## OFFICE OF ENVIRONMENTAL SUSTAINABILITY

### INSPECTOR'S REPORT ON AN APPLICATION FOR A CERTIFICATE OF AUTHORISATION FOR A CLOSED LANDFILL

<b>TO:</b>	David Flynn, Director	
<b>FROM:</b>	Ewa Babiarczyk, Inspector.	Circular Economy Programme
<b>DATE:</b>	5th November 2023	
<b>RE:</b>	Application by <b>Clare County Council</b> for a Certificate of Authorisation for a closed landfill at <b>Whitegate Landfill, Bargarriff, Whitegate, County Clare</b> . Certificate of Authorisation Register Number <b>H0035-01</b> .

**Figure 11: Proposed gas vents and perimeter berm**

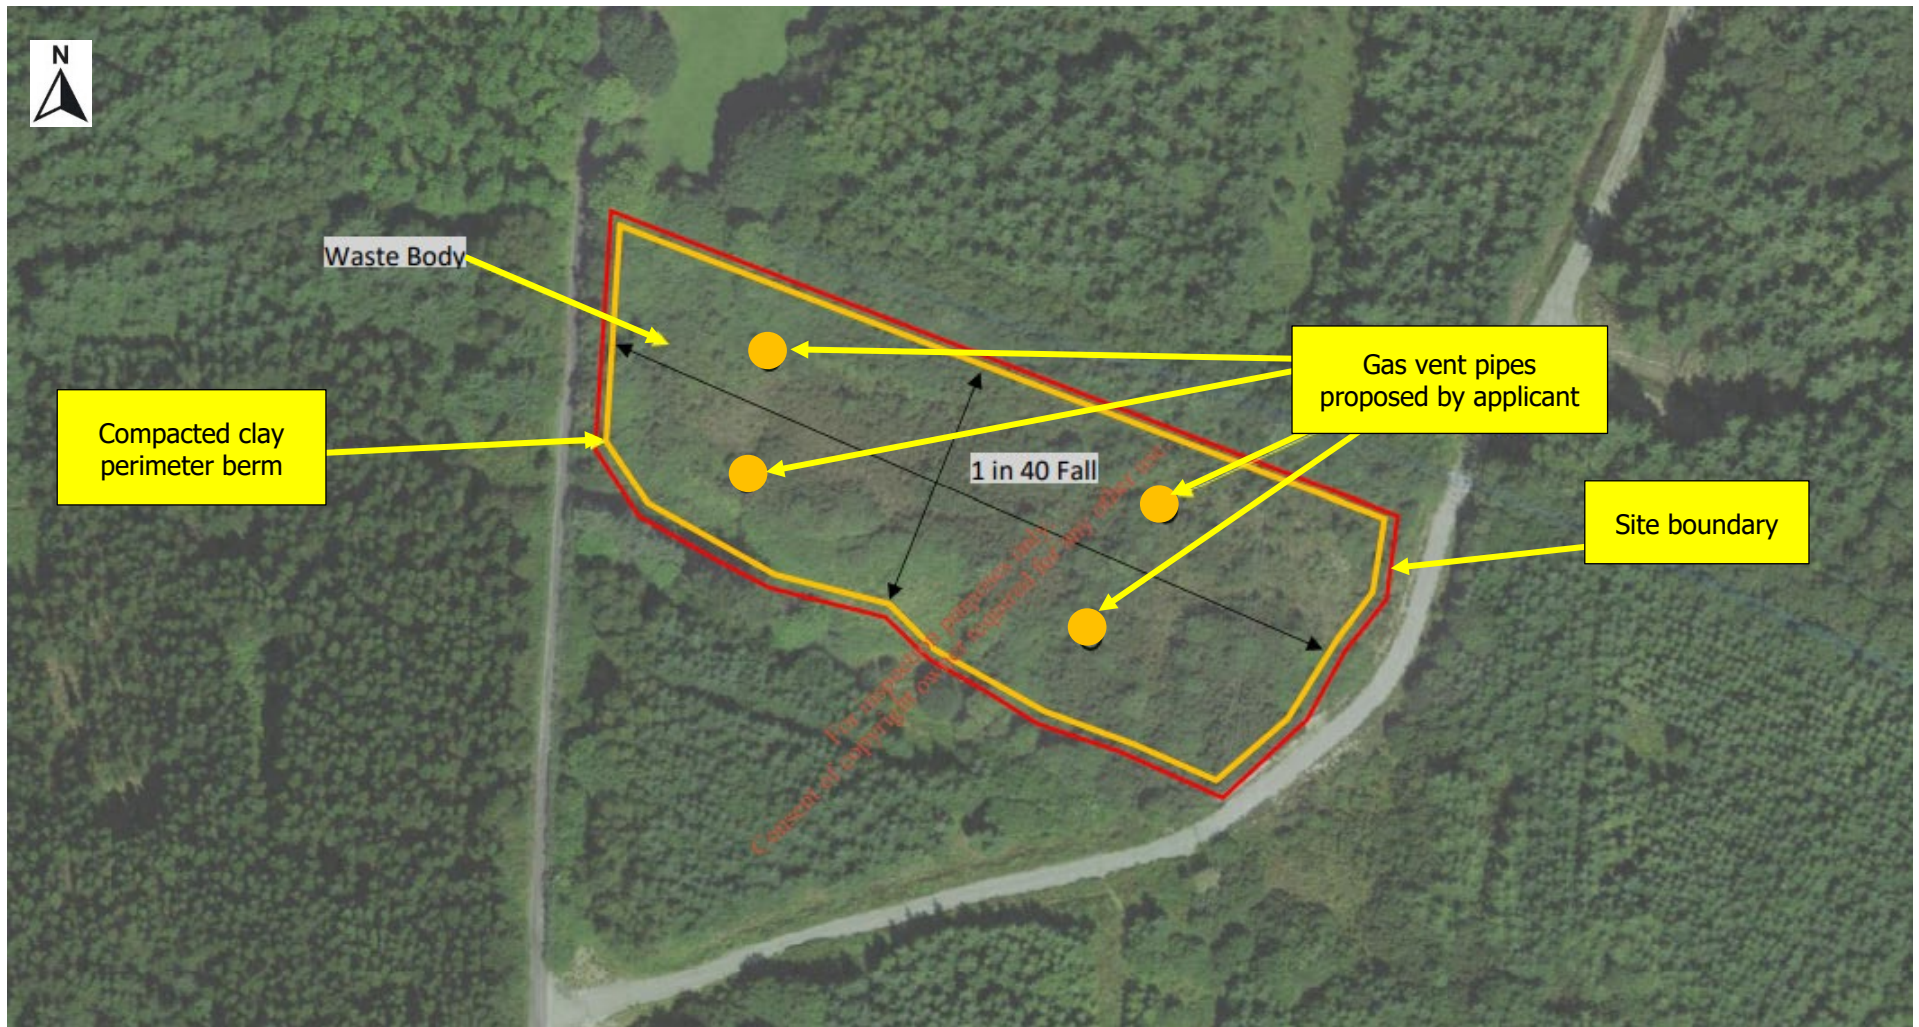
The applicant proposes installation of four gas vents in the waste body, one in each quadrant of the site to prevent lateral landfill gas migration, as shown in Figures 11 and 13.

Condition 3.1(c) requires a gas drainage layer within the cap and Condition 3.1(e) requires the installation of four gas vents in accordance with the *EPA Landfill Manuals – Landfill Site Design* and that spacing between the gas vent pipes shall be sufficient to achieve adequate gas venting.

**Figure 12: Proposed clay berm**

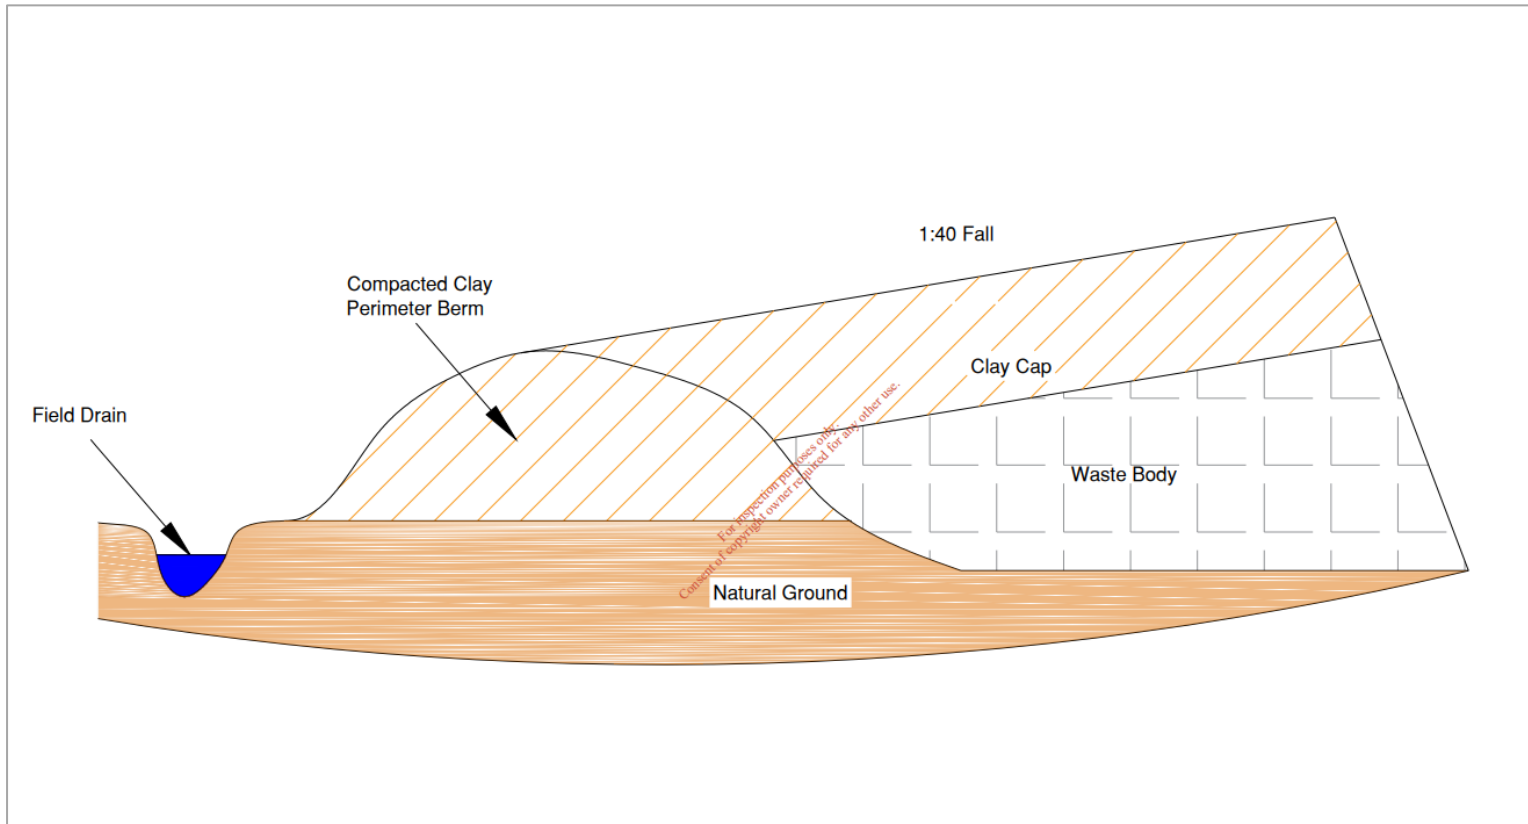
<p>Proposed remedial actions:</p>	<p>The applicant proposed the following remedial measures:</p> <p>1. <u>Landfill cap</u></p> <p>(i) 500mm layer of clean soil and perimeter berm;</p> <p>The applicant states that due to the nature of the waste and the low amenity use a 500mm capping layer over the waste may suffice. The applicant intends to import clean soil and build up the capping layer to achieve the 500mm thick capping layer across the site. The Tier 3 assessment further states that to prevent leachate break out along the sides, the sides of the landfill will also have to be sealed with a clay barrier, as shown in Figure 11 and 12.</p> <p>The Tier 3 assessments further recommends that the cap should be graded to achieve a fall from a central ridge, running north to south, to the sides of the capped site with a fall of 1:40, which will allow rainfall to run-off the landfill into the surrounding surface water drains rather than percolate through the waste. The Agency requires a detailed design of the cap to be submitted prior to installation.</p> <p>It is considered however that an engineered cap of 1m thickness is more appropriate for the landfill. This is due to the nature of leachate being generated that is migrating into adjacent surface water drains, the type of waste encountered during site investigations (e.g., car engine, oil drums or similar containers, animal medicine bottles, a fridge, car battery) along with the results of the surface water monitoring which indicate that the waste within the landfill is not inert. In accordance with the EPA Landfill Manuals – Landfill Site Design, a 500mm thick cap as proposed is more suited to a landfill for inert waste.</p> <p>Accordingly, Condition 3.1(c) requires a landfill cap that comprises</p>

of a minimum 1m thick mineral layer with 1mm thick low permeability geomembrane, or equivalent, to achieve a hydraulic conductivity of less than or equal to  $1 \times 10^{-9} \text{m/s}$ . Condition 3.1(d) requires installation of a compacted clay perimeter berm around the waste body and that the clay berm shall be integrated with the landfill cap and achieve the same hydraulic conductivity. Additionally, Condition 3.1(c) requires reprofiled gradients to provide for run-off of rainwater in accordance with *EPA Landfill Manuals – Landfill Site Design* and Condition 3.12 requires that only greenfield soil and stone, including greenfield soil and stone that meets by-product criteria, or soil and stone of equivalent nature and character, in terms of chemical and physical composition, can be imported for use in remedial, corrective, or other engineering works at the site.
